ADDENDUM NO. CC-3

22 January 2015

MILLARD NORTH HIGH SCHOOL  
CONNECTOR ADDITION  
1010 South 144<sup>th</sup> Street  
Omaha, NE 68154  
BCDM Project No. 3029-24

M1-0a

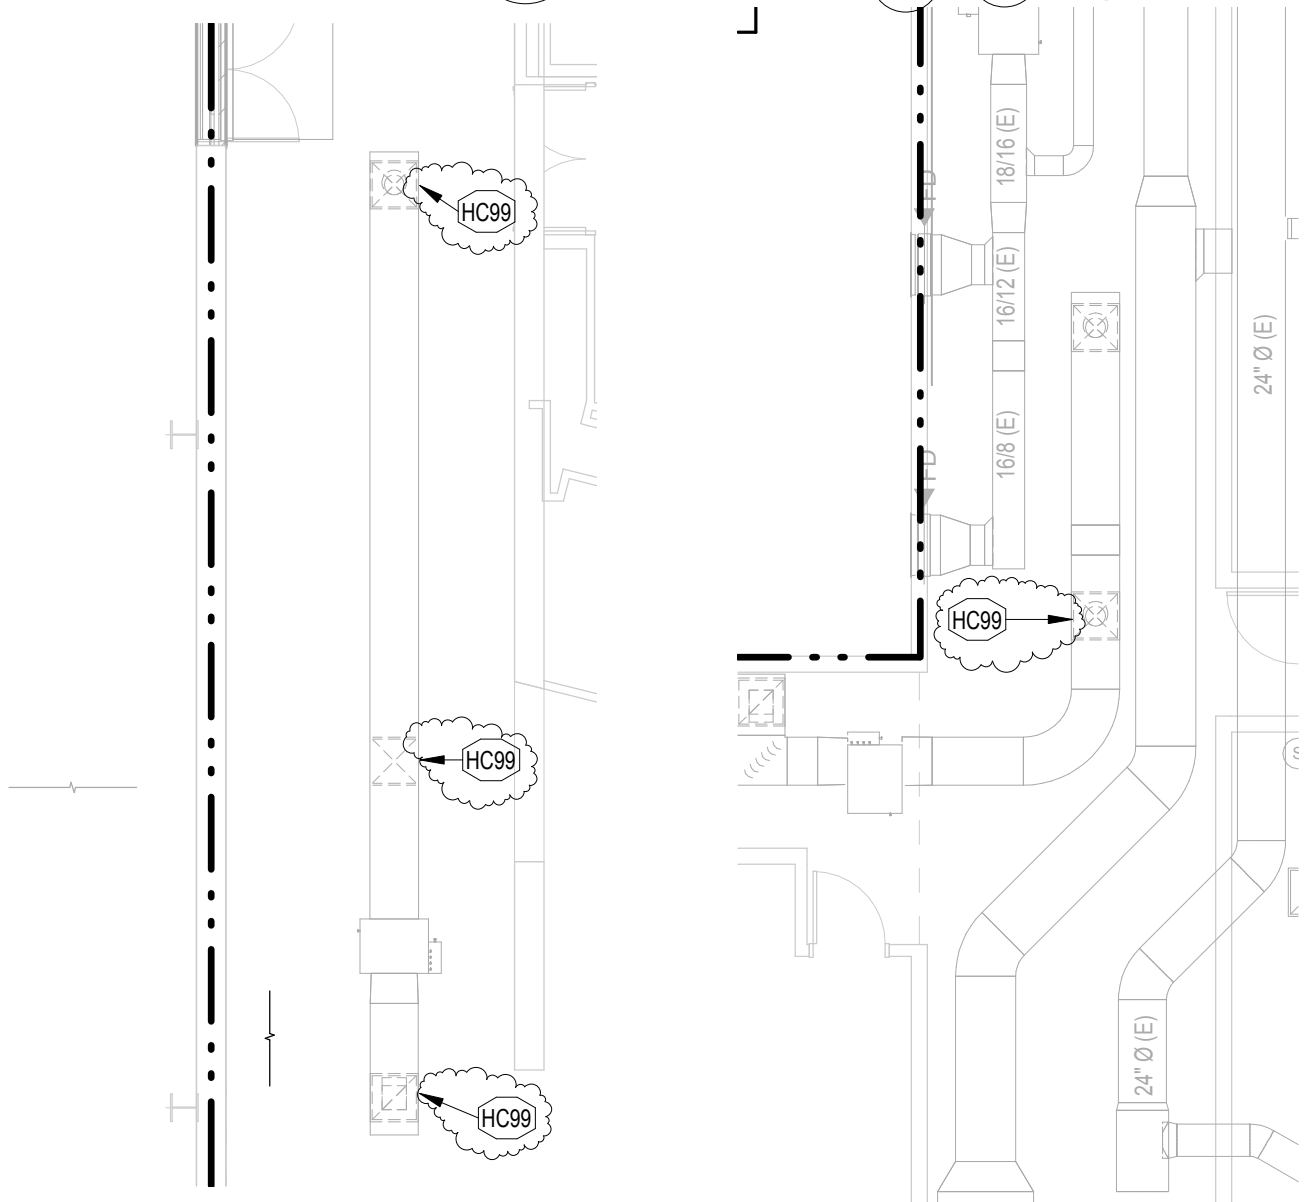
1. Sheet M1-0a – MECHANICAL PLAN - GENERATOR
  - a. Change MUD contact for the natural gas meter coordination to Tom Miller at 402-504-7938. See sketch M1-0a.
2. Sheet M1-1 – 1ST FLOOR HVAC PLAN 1
  - a. Remove and install existing grilles and diffusers in new ceiling. See sketch M1-1a.
3. Sheet M1-1A – MECHANICAL PLAN - 1ST FLOOR AREA 'A'
  - a. Add return air grille type G-5, change D-1 diffuser to sidewall mounted R-1. See sketch M1-1Aa.
4. Sheet M3-1A – PLUMBING PLAN - 1ST FLOOR AREA 'A'
  - a. Connect new BFS-1 to existing plumbing, see sketch M3-1Aa.
  - b. Adjust location of storm drains, see sketch M3-1Aa.
5. Sheet M7-2 - MECHANICAL SCHEDULES
  - a. Add grille type G-5. See sketch M7-2a.

EXISTING 2 PSIG NATURAL GAS SERVICE. EXISTING CONNECTED LOAD APPROXIMATELY 1,066 CFH. ADDITIONAL CONNECTED LOAD BY PROJECT APPROXIMATELY 660 CFH. CONTACT TOM MILLER AT 402-504-7938 TO COORDINATE ALL WORK ASSOCIATED WITH NATURAL GAS SERVICE.

.M1-1a

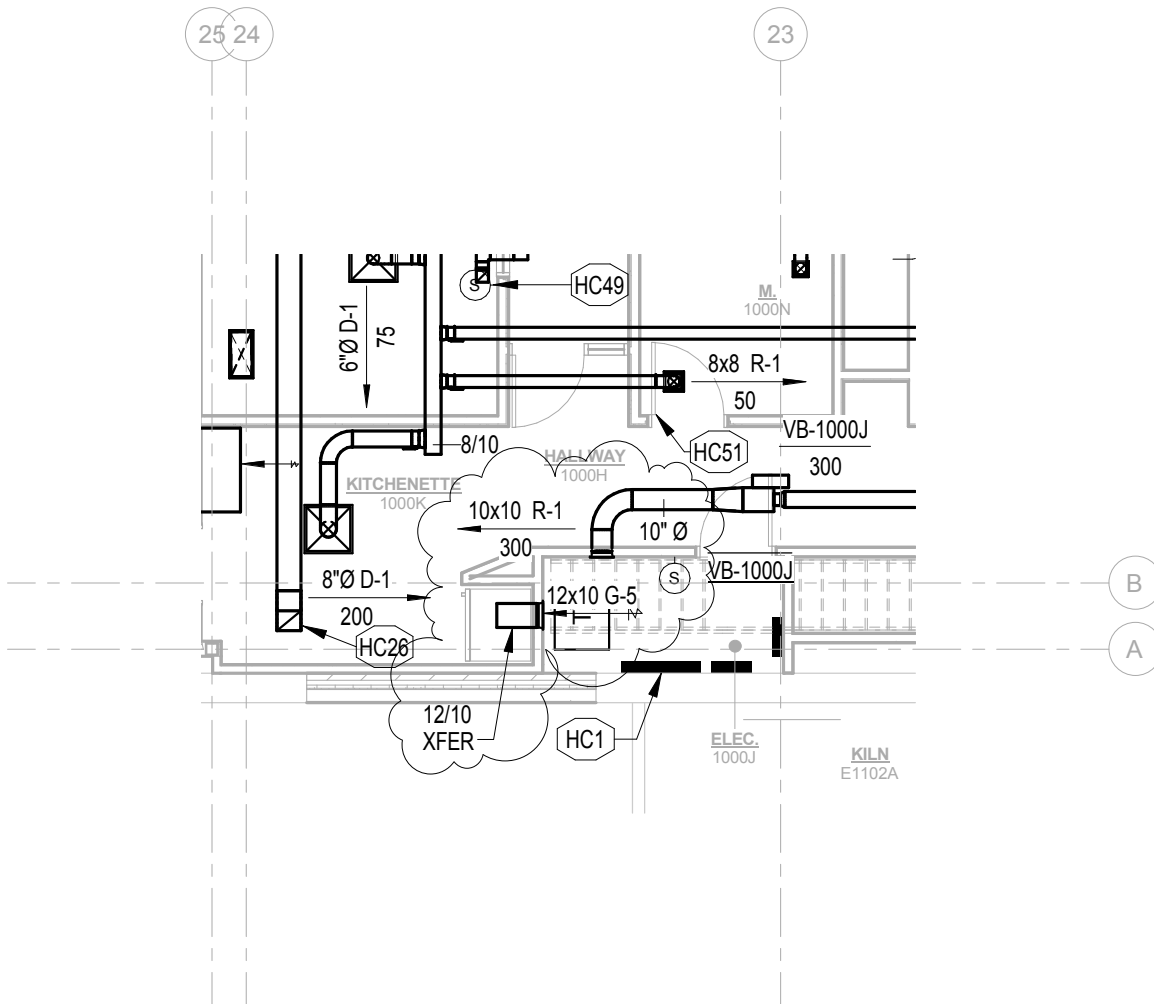
HC99 REMOVE DIFFUSER/GRILLE FROM EXISTING CEILING AND RELOCATE IN NEW CEILING. COORDINATE EXACT LOCATION WITH NEW CEILING GRID AND LIGHTS. ADJUST DUCTWORK AS REQUIRED FOR NEW LOCATION.

**M1-1Aa**

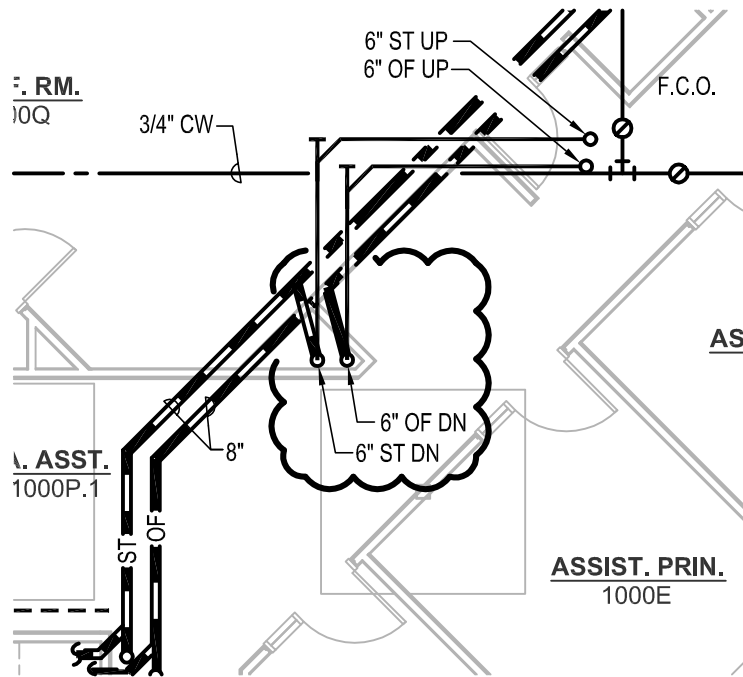
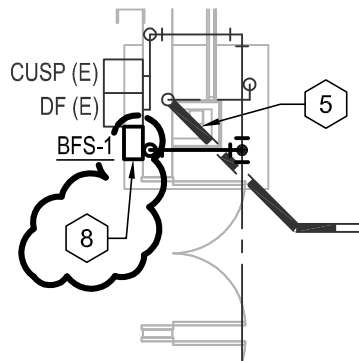
8 PROVIDE NEW WATER BOTTLE FILLING STATION NEXT TO EXISTING DRINKING FOUNTAIN. EXISTING DRINKING FOUNTAIN WILL NEED TO BE REMOVED TO FACILITATE INSTALLATION. ROUTE NEW CW AND WASTE THROUGH WALL AND CONNECT TO EXISTING PLUMBING.

**E1-1Ab**

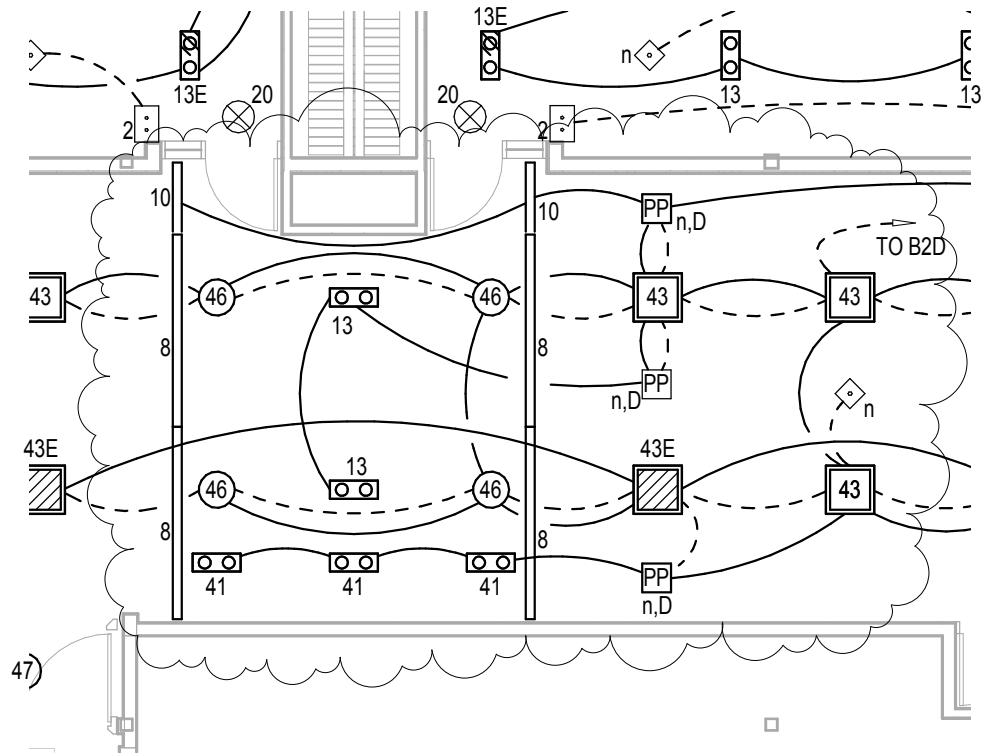
6. Sheet E1-1A – Floor Plan – 1<sup>st</sup> Floor - Area 'A' - Lighting
  - a. Add Type 49 sconce fixture in Hallway C1110 to columns. See sketch E1-1Aa and E1-1Ab.
7. Sheet E1-2A – Floor Plan – 2<sup>nd</sup> Floor - Area 'A' - Lighting
  - a. Delete Type 46 fixture in metal ceiling panel. Add Type 13 fixture in metal ceiling panel. Add cove lighting in gyp ceiling cove. See sketch E1-2Aa and E1-2Ab.
8. Sheet E2-1A – Floor Plan – 1<sup>st</sup> Floor - Area 'A' – Power
  - a. Provide receptacle for water bottle fill station in gym.
9. Sheet E3-2A – Floor Plan – 2<sup>nd</sup> Floor – Area 'A' – Special Systems
